# UNITED STATES PATENT AND TRADEMARK OFFICE

APPLICATION NO.	FILING DATE	FIRST NAMED INVENTOR	ATTORNEY DOCKET NO.	CONFIRMATION NO.
10/709,904	06/04/2004	Brad R. Graham	71575-0003	8744
20915	7590	05/10/2006	EXAMINER	
MCGARRY BAIR PC 171 MONROE AVENUE, N.W. SUITE 600 GRAND RAPIDS, MI 49503			CHAPMAN, JEANETTE E	
			ART UNIT	PAPER NUMBER
			3635

<b>Office Action Summary</b>	<b>Application No.</b> 10/709,904	<b>Applicant(s)</b> GRAHAM ET AL.	
	<b>Examiner</b> Chapman E. Jeanette	<b>Art Unit</b> 3635

FIG. 4

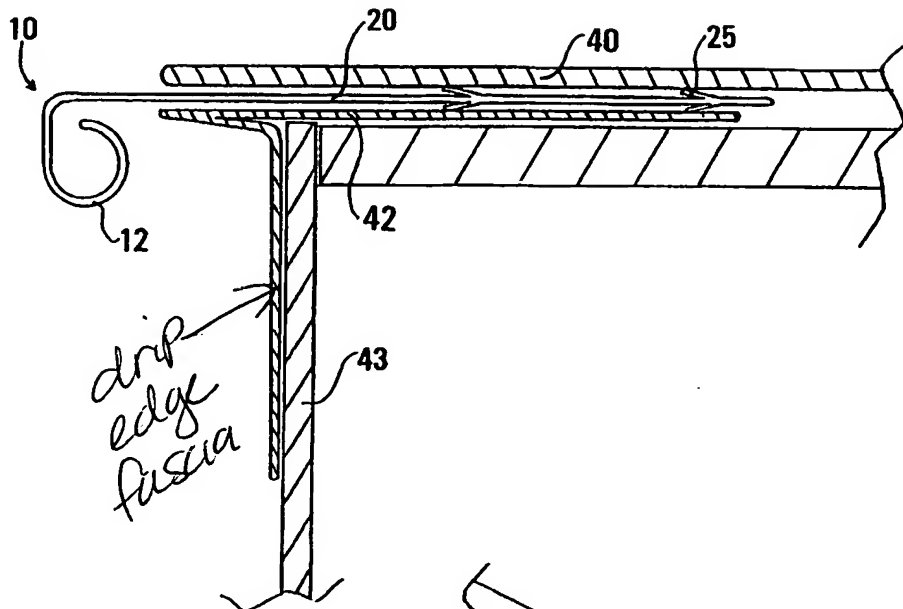
- With the measurements given in column 4, lines 38-46, the flexible portion 25 is disposed about 1 inch from the frontal piece 12/14
- The strengthening portion has ribs 25; see annotations on patent copy

- the drip edge 10 and the fascia cover 80 will not buckle with thermal changes
- the drip edge is made of vinyl ; see above
- the drip edge 10 has a face 42 that covers a portion of the fascia cover 60 when the drip edge and the fascia system is mounted to a structure; see figures 3-5 and where the figures 4 and 5 meet in figure 3
